# UNITED STATES PATENT AND TRADEMARK OFFICE

APPLICATION NO.	FILING DATE	FIRST NAMED INVENTOR	ATTORNEY DOCKET NO.	CONFIRMATION NO.
10/664,087	09/16/2003	Chester Lawrence Mallory	TP-1	3723

<p align="center"><b>Office Action Summary</b></p>	<p><b>Application No.</b></p> <p align="center">10/664,087</p>	<p><b>Applicant(s)</b></p> <p align="center">MALLORY ET AL.</p>	
	<p><b>Examiner</b></p> <p align="center">Philip Gabler</p>	<p><b>Art Unit</b></p> <p align="center">3637</p>

Lewis '372 Figures 1, 4, and 5

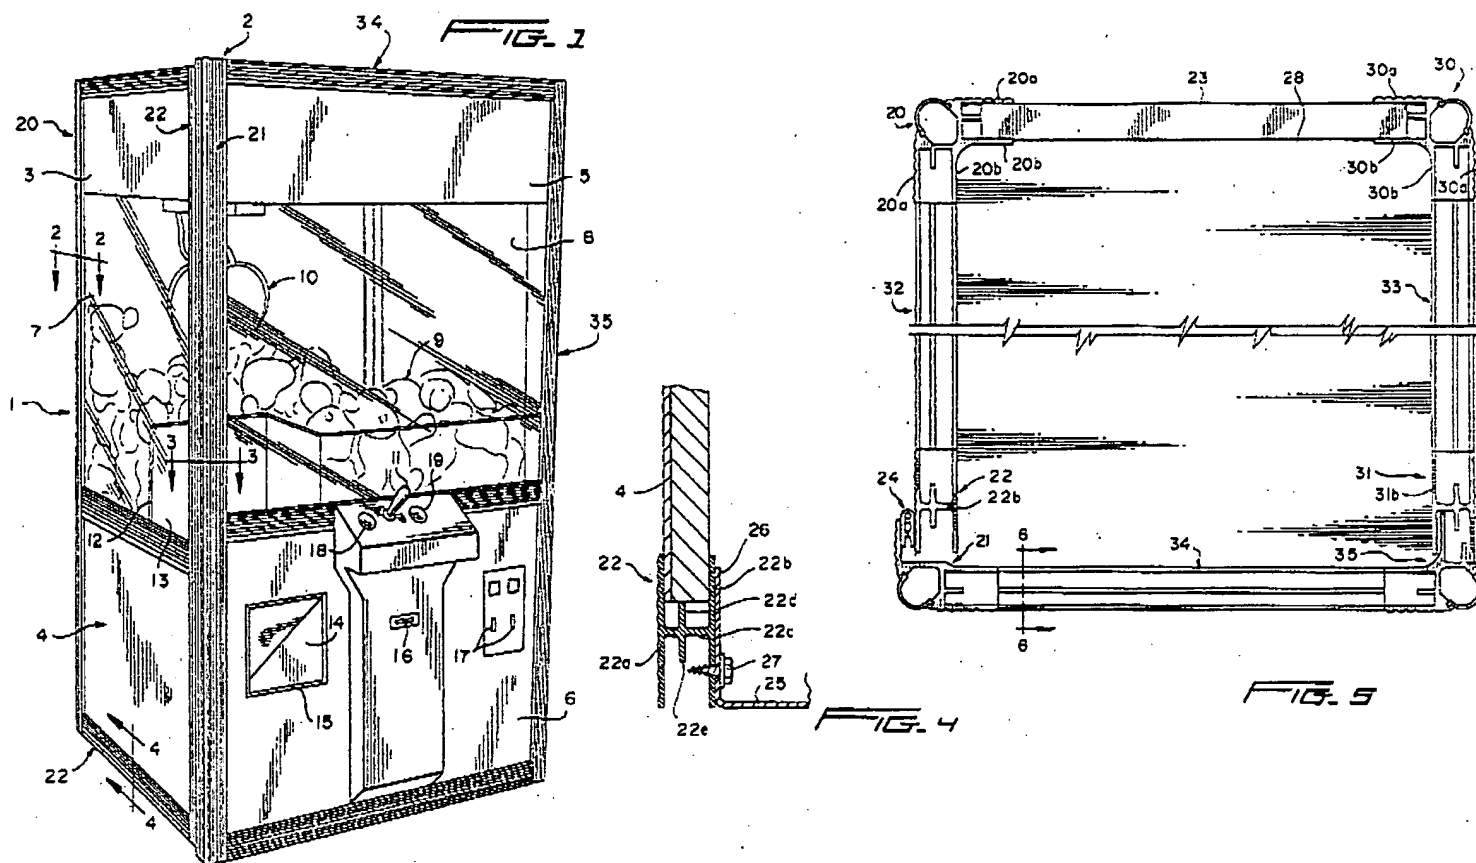
3. Claims 1-3, 8-11, and 20-22 rejected under 35 U.S.C. 103(a) as being unpatentable over Lewis (US Patent Number 5549372).
4. Regarding claims 1 and 22, Lewis (Figures 1, 4, and 5) discloses a security enclosure for a gaming machine system comprising: a gaming machine main housing (1) defining a chamber and having a major opening (at the front of the cabinet); a gaming machine door assembly (the front panel assembly covering the opening) operably connected to the gaming machine main housing and movable between an open position providing external access to the chamber and a closed position securing the major opening (shown only in the closed position, but an open position is discussed in column 2 lines 38-44, for instance); and the gaming machine door assembly comprising a plurality of components (5, 6, 8, 21, 34, 35, etc.), at least some of the components being elongated members (21, 35, etc.) including vertical elongated members and horizontal elongated members having fasteners (viewed as the shaped ends of vertical members 21, 35, for mating with other components) at opposed end portions thereof capable of coupling the vertical elongated members with the horizontal elongated members and facilitating individual finishing of the components (in as much as Applicant's fasteners do so); wherein the components are individually finished (the

various components, all separable and made of varying material, are viewed as individually finished). Lewis does not specifically disclose fasteners on the each of the elongated members for directly coupling the vertical and horizontal elongated members. He does however disclose fasteners (27, as well as the fasteners mentioned above) for connecting various components of his assembly. Accordingly, it would have been obvious to one of ordinary skill in the art at the time the invention was made to include fasteners at the ends of the elongated members for securing the members because this would insure a solid connection between the components and provide a more solid assembly.

5. Regarding claim 2, Lewis, modified as described above, further discloses the vertical elongated members comprise a pair of opposed vertical stiles (members 21 and 35) each having an upper end, an opposed lower end, and an intermediate portion, the horizontal elongated members including at least one cross member (34) extending between the stiles, the cross member having opposed ends having a fastener engaging a corresponding fastener on each of the stiles.

6. Regarding claim 3, Lewis, modified as described above, further discloses the horizontal elongated members comprise a top rail, an intermediate rail, and a bottom rail (all 34, see Figure 1) extending between the upper ends, intermediate portions, and lower ends of the stiles respectively.

8. Regarding claim 10, Lewis further discloses at least one of the door components has a different surface finish than other door components (components 5 and 6, for instance, are finished in a decorative manner, as opposed to component 8, which is not).

10. Regarding claims 20 and 21, Lewis further discloses individual finishing of at least some of the components includes coating or plating (column 2 lines 50-52 describes a laminate, viewed as a coating or plating). [Note that the disclosure specifically refers to panel 4 regarding the surface finish, however, it is clear from the figures and disclosure that panels 3-6 are all to be finished in the same manner.]

### Exhibit 1: Halic '195 Figures 2 and 3

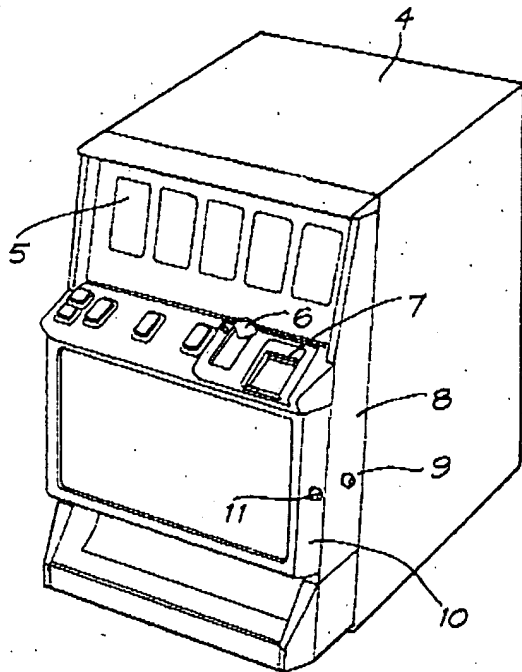
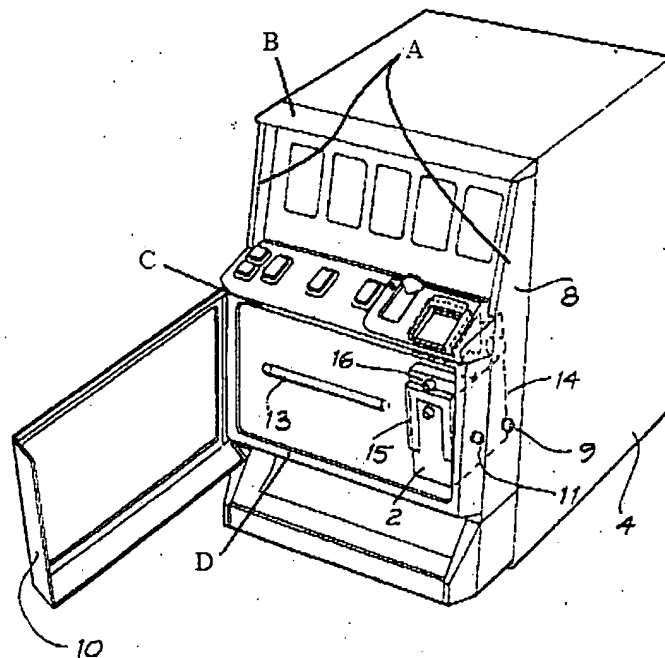
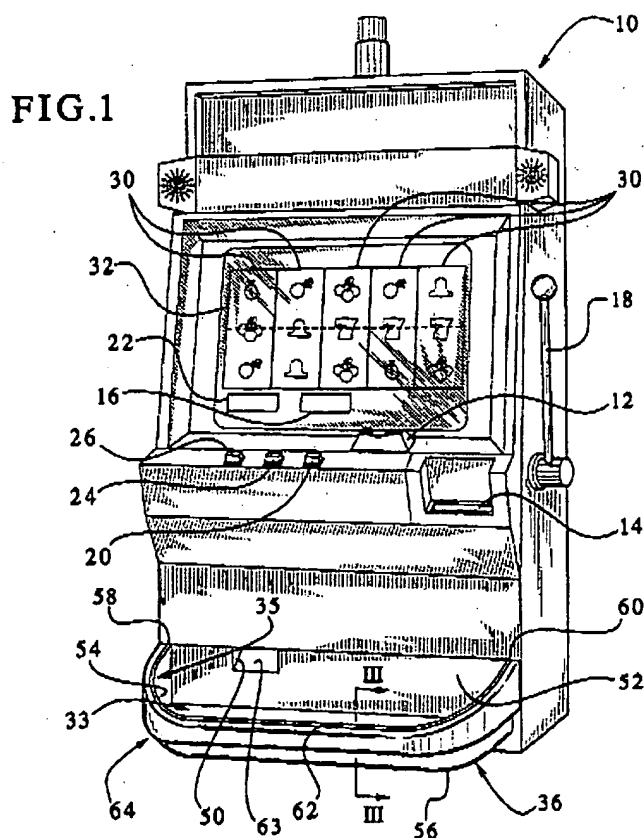
12. Regarding claims 1 and 22, Halic (Figures 2 and 3) discloses a security enclosure for a gaming machine system comprising: a gaming machine main housing (4) defining a chamber and having a major opening (at the front of the cabinet); a gaming machine door assembly (8) operably connected to the gaming machine main housing and movable between an open position providing external access to the chamber and a closed position securing the major opening (shown only in the closed

position, but an open position is discussed in column 2 lines 50-52, for instance); and the gaming machine door assembly comprising a plurality of components (viewed as elements A, B, C, D, etc. in Exhibit 1), at least some of the components being elongated members (members A and B for instance) including vertical elongated members and horizontal elongated members. Halic does not specifically disclose fasteners at ends of the components or individual finishing of the members. Lewis discloses an enclosure for a gaming machine system including fasteners (27) for mating ends of elongated components. Accordingly, it would have been obvious to one of ordinary skill in the art at the time the invention was made to use fasteners at the ends of members as taught by Lewis for connecting the various members of Halic's door assembly because this would insure a solid connection between the components and provide a more solid assembly. When modified in this manner, Halic's enclosure system would facilitate individual finishing of his components (in as much as Applicant's device does so). Further, Lewis discloses individually finished components (the various components, all separable and made of varying material, are viewed as individually finished). Accordingly, it would have been obvious to one of ordinary skill in the art at the time the invention was made to individually finish the various components of Halic's device as taught by Lewis because this would allow a varied and individualized aesthetic as desired by a user by allowing the components to be finished in a manner pleasing to a particular owner or user.

13. Regarding claim 2, Halic, modified by Lewis as described above, discloses the vertical elongated members comprise a pair of opposed vertical stiles (A) each having

an upper end, an opposed lower end, and an intermediate portion, the horizontal elongated members including at least one cross member (B) extending between the stiles, the cross member having opposed ends each having a fastener engaging a corresponding fastener on each of the stiles (at least a hole for receiving a screw).

14. Regarding claim 3, Halic further discloses the horizontal elongated members comprise a top rail (B), an intermediate rail (C), and a bottom rail (D) extending between the upper ends, intermediate portions, and lower ends of the stiles respectively.

15. Regarding claim 4, Halic further discloses a belly door (10) connected to the gaming machine door assembly and operable between an open position in which a selected one of the rails (D) is visible (see Figure 3), and a closed position in which the selected one of the rails is concealed (see Figure 2, where D is concealed).

20. Regarding claims 23 and 24, Halic, when modified by Lewis as described above, further discloses an additional door (10 and associated components) pivotally coupled to the door assembly wherein the additional door conceals at least one of the horizontal elongated members (D) when closed (see figures).

21. Regarding claim 25, Halic, when modified by Lewis as described above, further discloses the additional door includes a belly door (15).
